UNITED STATES PATENT AND TRADEMARK OFFICE

Office Action Summary	Application No. 10/783,499	Applicant(s) ZIPFEL ET AL.	
	Examiner Michael B. Shingleton	Art Unit 2815

DETAILED ACTION

Comparison Illustration.

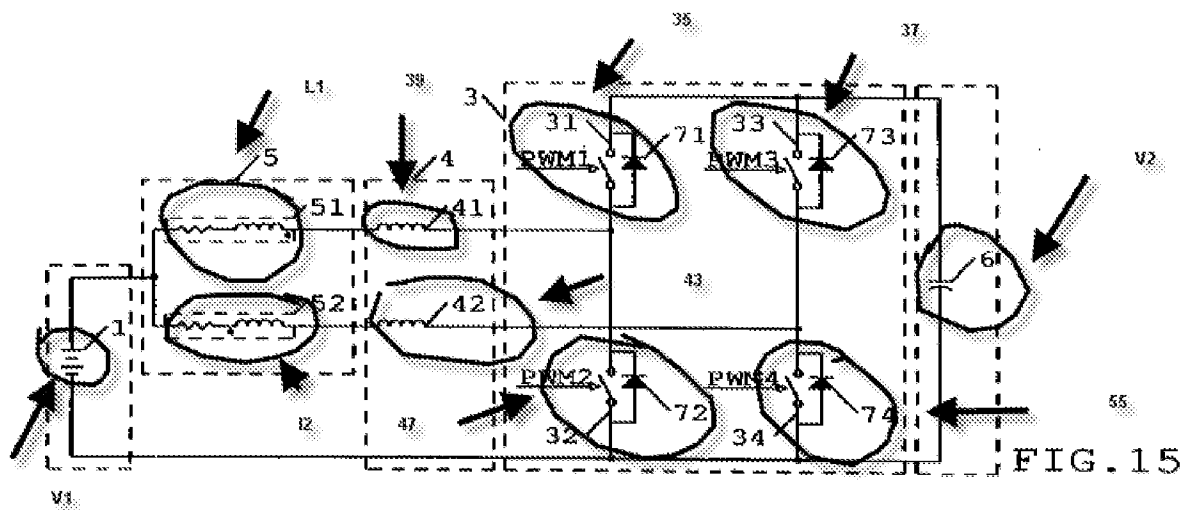
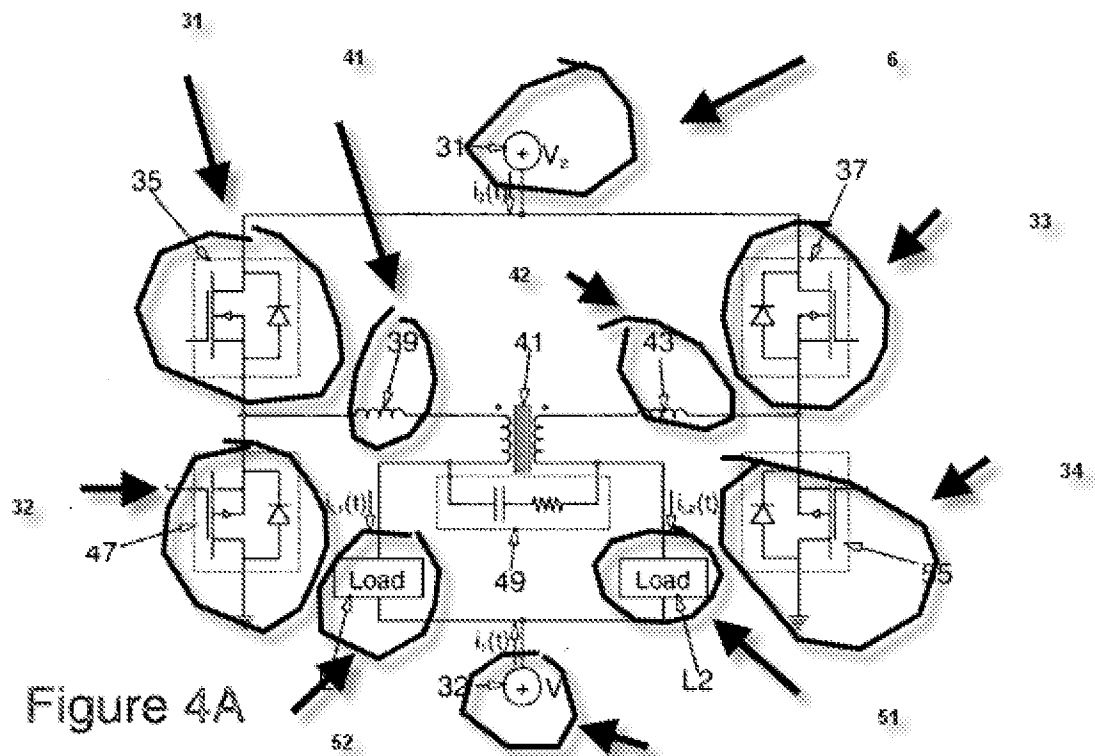
Applicant appears to make an issue of the PWM signals being “in-phase” with transistors 35 and 37 of the disclosed invention being both roughly “on” at the same time (See page 12 around line 23 of the instant application.), as compared to what might be considered “out of phase” pwm signals of the prior art where transistor 31/PWM1 is “on” and transistor 33/PWM3 is “off” roughly at the same time in the prior art. See column 7 around line 61 of Prokin., but in actuality the baseband signals of both the prior art and the present invention that are applied to their two respective loads appear to be 180 degrees out of phase and thus the instantaneous currents through the first and second reactive loads is substantially zero just like claim 1 has been amended to read (This is addressed in the rejections in more detail.). Also the fact of the matter is that at least the independent claims are just not so limited to the PWM signals being “in-phase” as apparently meant by applicant and these claims are more directed toward the description of the function of having the baseband signals applied to the two loads being out of phase with each other which the prior art clearly, i.e. inherently, includes, as is addressed in more detail in the rejection(s). As also noted the claims just do not claim the specific structure of the transistors/switches 35, 37, 47 and 55 of Figure 4A, but even if applicant did claim the specific structure of the transistors/switches 35, 37, 47 and 55 of Figure 4A the structure is the same with that of the switches 31, 33, 32, and 34 of the prior art. The inverter and load structure of the prior art and the disclosed invention are the same as addressed in the previous office action.

Again as stated above, the prior art has the same result as applicant's invention and as noted in the previous office action there is no difference in the inverter/load structure between the disclosed invention and the invention of the prior art. Also see the "Comparison Illustration" above. These two methods of operating, i.e. the preferred method of the prior art and the preferred method of the instant application are also looked upon as two art-recognized equivalent methods of operating the same device. Again many of the claims of applicant's invention are directed toward structure and the structure is not different between the prior art and applicant's disclosed invention. Thus this discussion between the difference between the method of the disclosed invention and the preferred method of the prior art does not have much bearing on the claims as the claims presented are not method claims but claims drawn to structure and most if not all of the claims don't even relate to the so called "in-phase" and "out-of-phase" PWM signals. However, it is important to note so as to understand the rejection and respond to applicant's arguments as these arguments are directed more toward a method and not a structure. In the disclosed method of the instant application the two baseband signals are caused to be out-of-phase by using the inverse of the baseband signal to be applied to only "one side" of the inverter structure to come up with one of the two PWM signals, i.e. the "PWM" signal. How one intends to use an old structure does not define a different or new structure. The old structure still remains an old structure. Also it has been long held that the discovery of how the prior art works does not present patentable distinction in claims drawn to structure. Also additionally as pointed out to the applicant many times in claims drawn to structure, the claims must be distinguish by structure. MPEP 2114 clearly states that "while features of an apparatus may be recited either structurally or functionally, claims directed to an apparatus must be distinguished from the prior art in terms of structure rather than function. In re Schreiber, 128 F.3d 1473, 1477-78, 44 USPQ2d 1429, 1431-32 (Fed. Cir. 1997)". Note that the Schreiber case was directed toward the pop corn funnel and the prior art did not recite the concept of using the prior art for pop corn, however, the structure claimed was met by the prior art. If an old structure is capable of performing the function then this old structure will clearly meet claims reciting these functions. If one applies PWM and PWM' signals to the prior art structure of Prokin such that the signals cause transistors 31 and 33 to be "on" about the same time ("in-phase") and the baseband signal super-imposed on the PWM' signal to transistors 33 and 34 of Prokin is the inverse of the baseband signal then Prokin would function exactly as the disclosed invention, so there is no question that the device of Prokin is fully capable of functioning the same as the disclosed invention. It is noted that the claims are much broader in the reciting function than in the disclosed invention, but this only shows that if applicant were to include more narrow limitations of pure intended use that the Prokin may be fully capable or performing the intended use.

Basic Illustration 1.

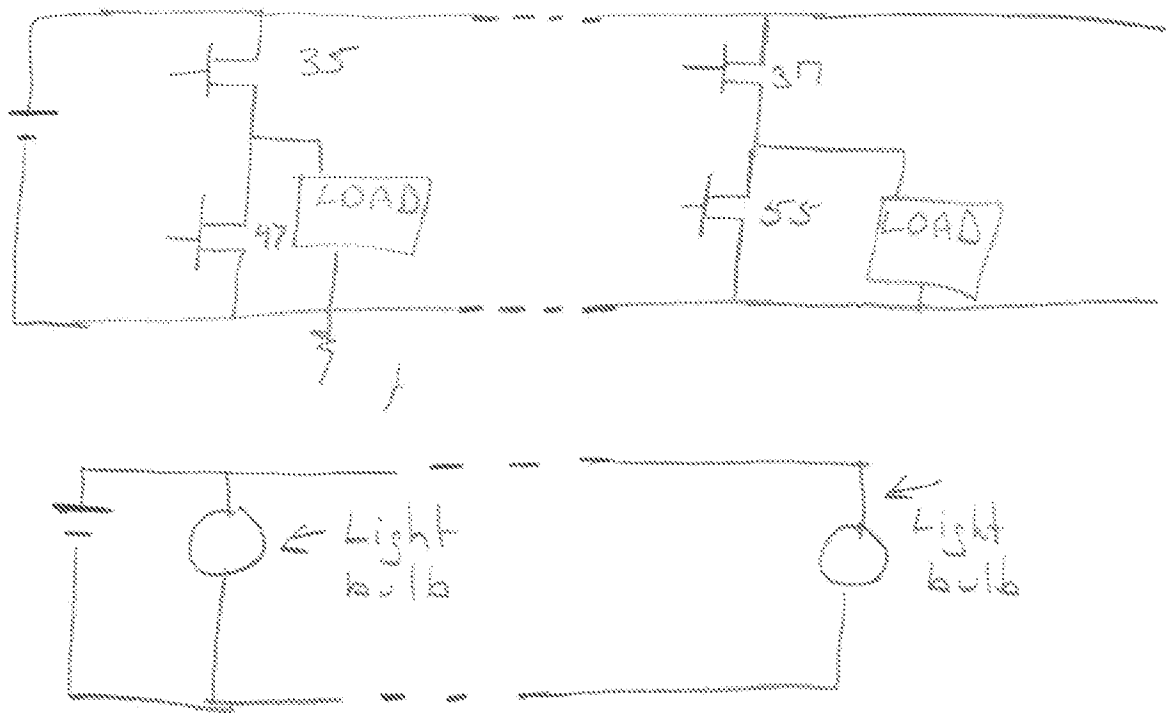
The examiner also feels that it is necessary due to applicant's remarks/arguments and to make clear to others some basic engineering features involved. It is just a common fact that in circuit analysis that a DC source acts as a short to an AC signal. So applicant's invention is more in tune to two separate push-pull or inverter arrangements that share a common ground. This is like separate light bulbs connected in parallel. Prokin also recognizes this fact in its illustration of Figure 11. The illustration below illustrates the basic arrangement of both Prokin and applicant's invention. See Basic illustration 1.

Basic Illustration 2.

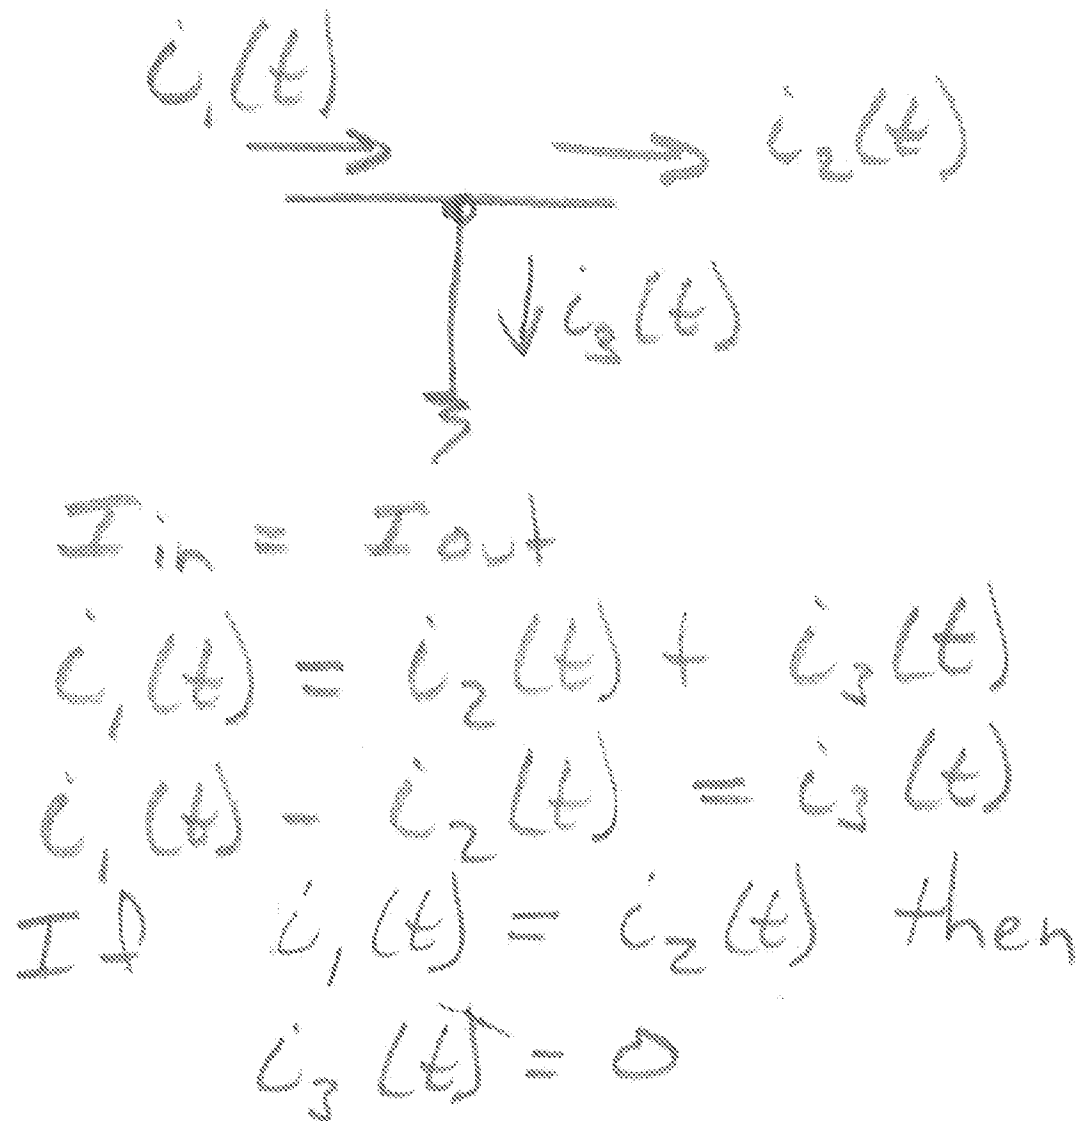
When the baseband currents are equal and opposite through the two loads then there is no baseband current through the “ground lead” as illustrated above. This is what occurs in Prokin and is the subject of the alternative description of the same function of the invention as presented in claim 9 and compared to claim 1. This fact that there is no current is based on the fact that the current into a node must equal the current out of the node, a basic engineering feature. With this then what flows into this node from one load is the current that flows into the other load. Again this is what happens in Prokin as

Speaker illustration number 2.

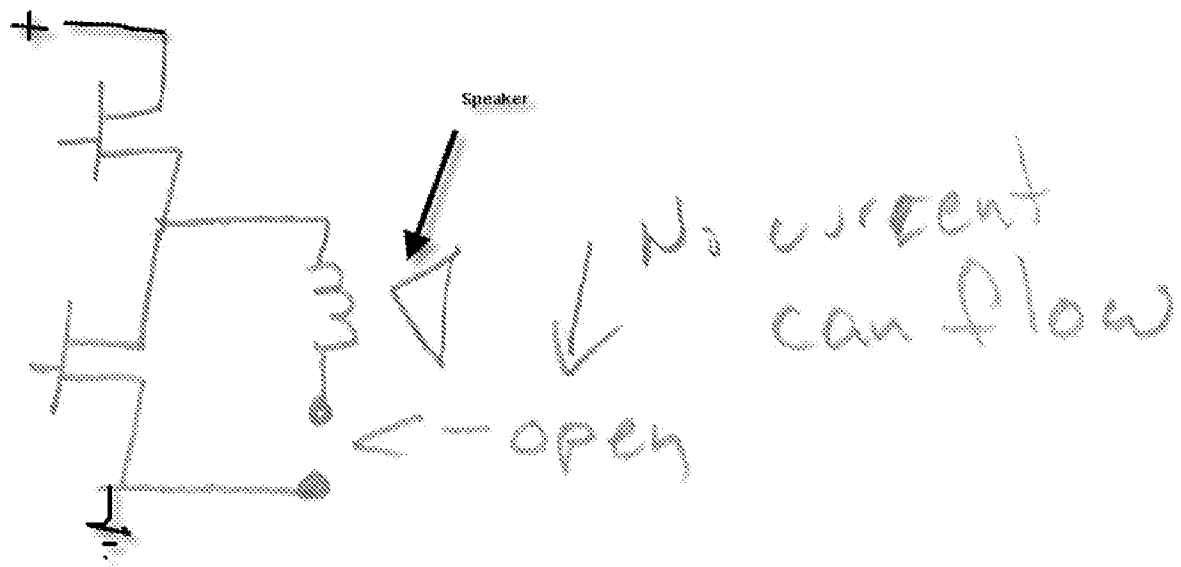
will be discussed in more detail below. Also note that if the DC source did not act as a short to AC, but as an open circuit then it would be impossible for the basic inverter or push pull unit like that of applicant's invention and that illustrated in Figure 11 of Prokin to have a return current path and thus the speaker would not speak or work. See Speaker Illustration number 2.

Figure 4a of the instant application.

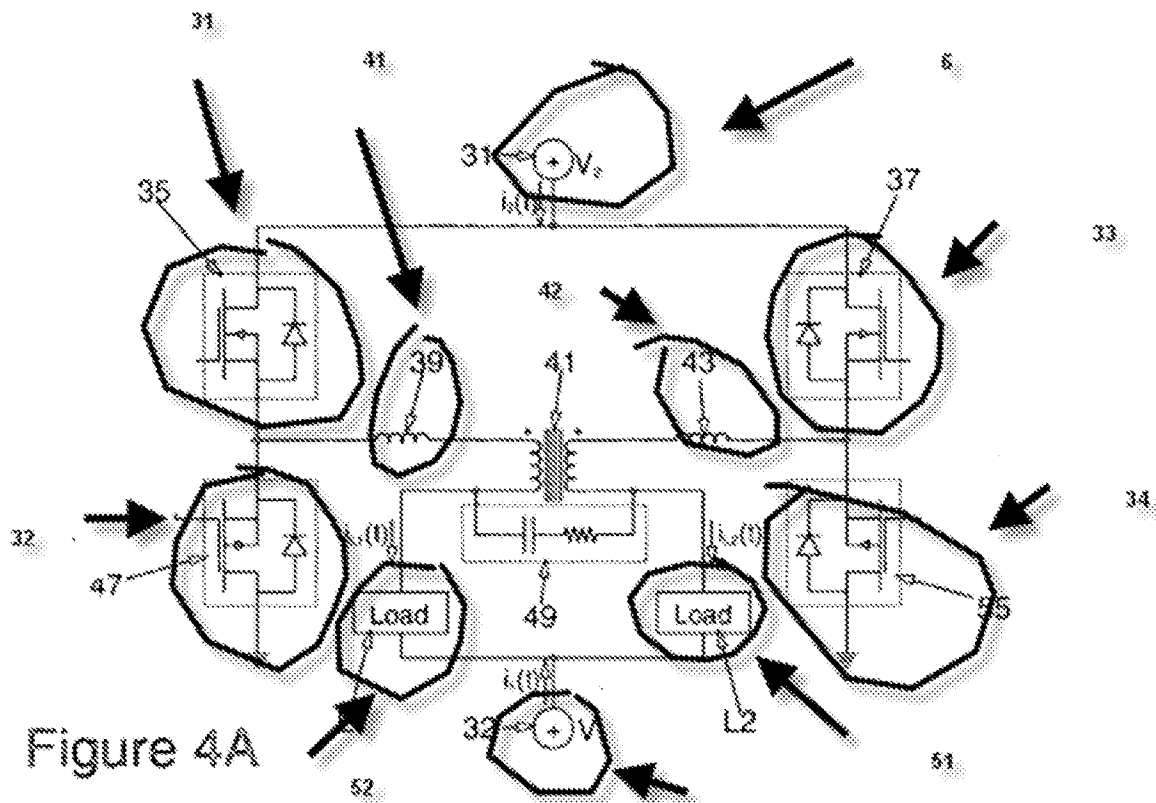
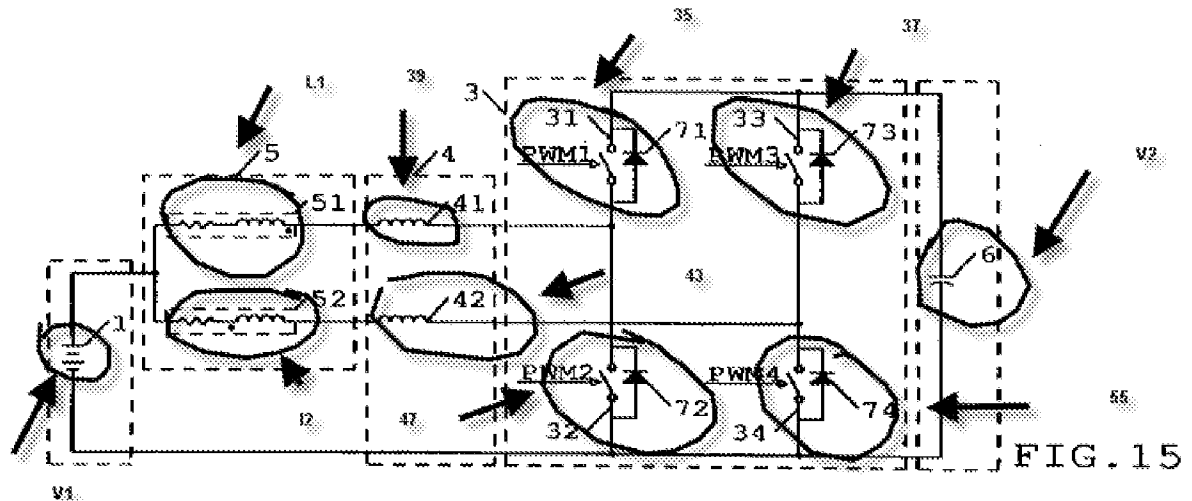
See elements 31 and 32 are part of the means that forms a first switching signal and elements 33 and 34 that forms a second switching signal of Prokin. Compare that to the disclosed invention of Figure 4a. The switching band component is the same as that of applicant's disclosed invention and that is a

square-wave and as mentioned above the device of Prokin is for an audio function (It is to power voice coils.) wherein the baseband component is applied by the pulse width modulation of the square-wave just like that of applicant's disclosed invention. (See Figure 4a of the instant application and Figure 15 of Prokin.)

Above shows the elected invention of Figure 4a. The interconnected load for the switching amplifier is shown above. While the claims lack any detail of the switching amplifier (Just now referred to as just "apparatus" in some of the claims. The examiner has cited Prokin of record for the switching amplifier is the same as that noted above. Below the examiner has provided a copy of Figure 15 of Prokin.

As recited by Prokin the bridge capacitor 6 supplies the power for the switching amplifier (See the abstract and the relevant text in the specification of Prokin.). As one can see from the above drawings the switching amplifier of Prokin is the same structure as that of applicant's elected invention. Note the four transistors. Thus the claimed structure to the switching amplifier is anticipated by Prokin in so far as the claims are understood. Note that the switching amplifier has output lines to the interconnected load and thus these are means for applying the baseband components. Note the common power supply node of element 1 of Prokin. Note that the switching amplifier of Prokin has "at least one power supply terminal" in the bridge capacitor or element 1 as set forth by at least claim 14. The four transistors like that of applicant's four transistor structure switching amplifier produces an alternating polarity of currents (See claim 22 of the instant application.). The use of PWM signals do not define any switching amplifier structure but never the less Prokin has PWM signals applied to the four transistors that make up the switching amplifier structure. The output lines are the means for supplying the two switching signals to the interconnected load (See claim 24 of the instant application.) As stated in the previous office action, if one were to connect the interconnected load to the switching amplifier of Prokin this would result in the combination functioning exactly as that of applicant's combination of switching amplifier and

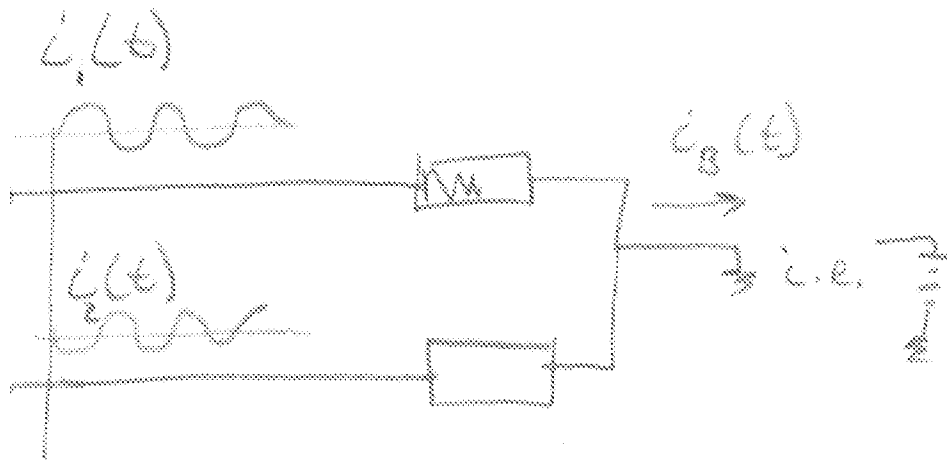
See the two wires that are used to apply the switching signals to the loads as illustrated above.

Note that other elements of the prior art could also meet this claim language limitation.

Speaker illustration number 1.

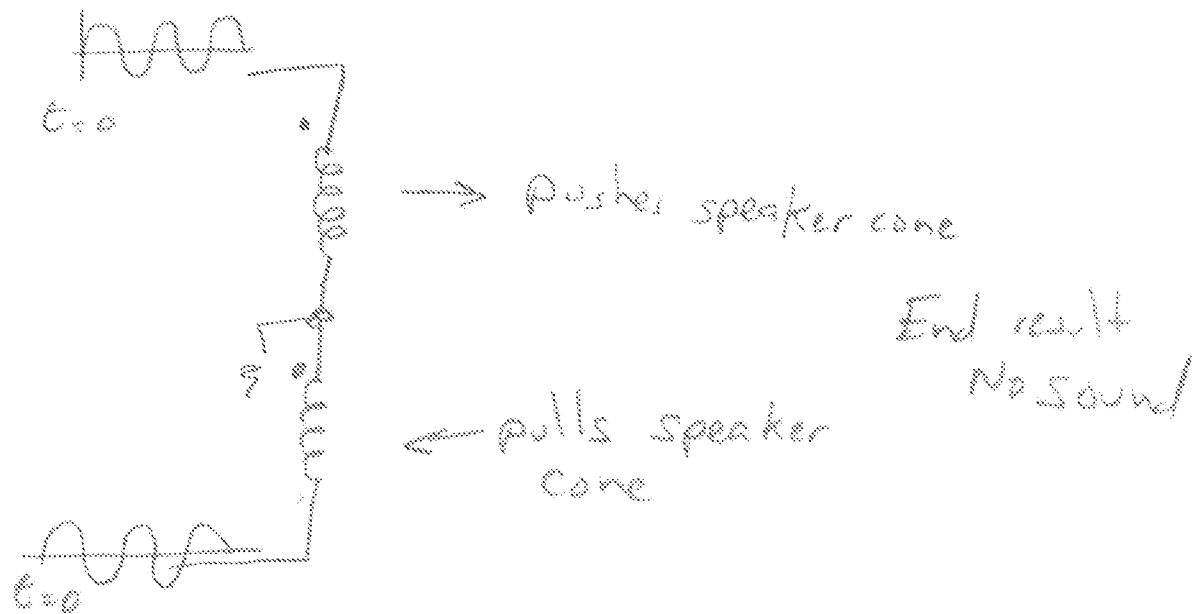
As noted above the baseband signals that are applied to the two loads in the Prokin prior art are out-of-phase just like that of applicant's invention. This inherently exists because of the “alternative” switching of the inverter transistors in the Prokin arrangement as noted above and more particularly this is further supported by the fact that in one preferred embodiment of Prokin a dual coil speaker is used. Note the “dot convention” of Figure 15. If the base band signals were not complementary or of opposite phase then the speaker would not produce any sound as the voice coils would cancel each other out. See the drawing called “Speaker illustration number 1” below that should help applicant see this fact.

Push Pull illustration.

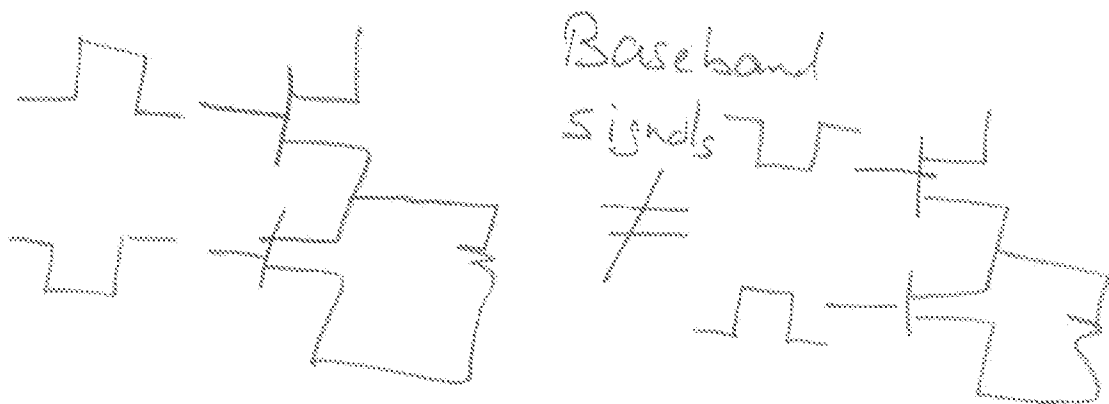
To further illustrate this fact that the baseband currents are of opposite magnitudes note the push and pull nature of the Prokin prior art, i.e. the "alternative" switching. See push pull illustration below.

In the Push Pull illustration note that with the exact opposite PWM signal applied to the "pull" transistor as compared to the "push" transistor the baseband signal just cannot be the same and are in fact 180 degrees out of phase with each other. To explain this in more simple terms note that when you filter out the high frequency signal what you have left is the width of the pulses defining how much the positive magnitude is (Push) and how much the "negative"(ground) magnitude is (pull). When the pull magnitude is at the highest in one push/pull arrangement the Push magnitude is at its highest in the other push/pull arrangement. In other words the baseband signals are opposite or 180 degrees out of phase between the two push/pull arrangements. (Note that the claims are drawn to structure so even if the examiner were to be incorrect in baseband signals are not the same for the two push pull circuits operated in an opposite manner as illustrated in the push pull illustration above, still applying the yet unclaimed disclosed control signals to the prior art does not impart patentability to the structure as the structure is the same and merely applying signals to an old structure that is different from the norm does not make that structure new. It is the same old structure. What applicant will be getting should this application become a patent is the right to exclude others from making the claimed structure. **There must be no "ambiguity" as to what that structure is.** See Halliburton Energy Services, Inc. v M-I LLC, Fed. Cir. 2007-1149. The examiner has constantly pointed to MPEP 2114 where the patent office requires this of the claims. Thus what is needed here in this application is clear limitations of structure to distinguish over the prior art so as to provide a clear indication to the public as to what structure applicant will be allowed to exclude others from making should this application become a patent.)
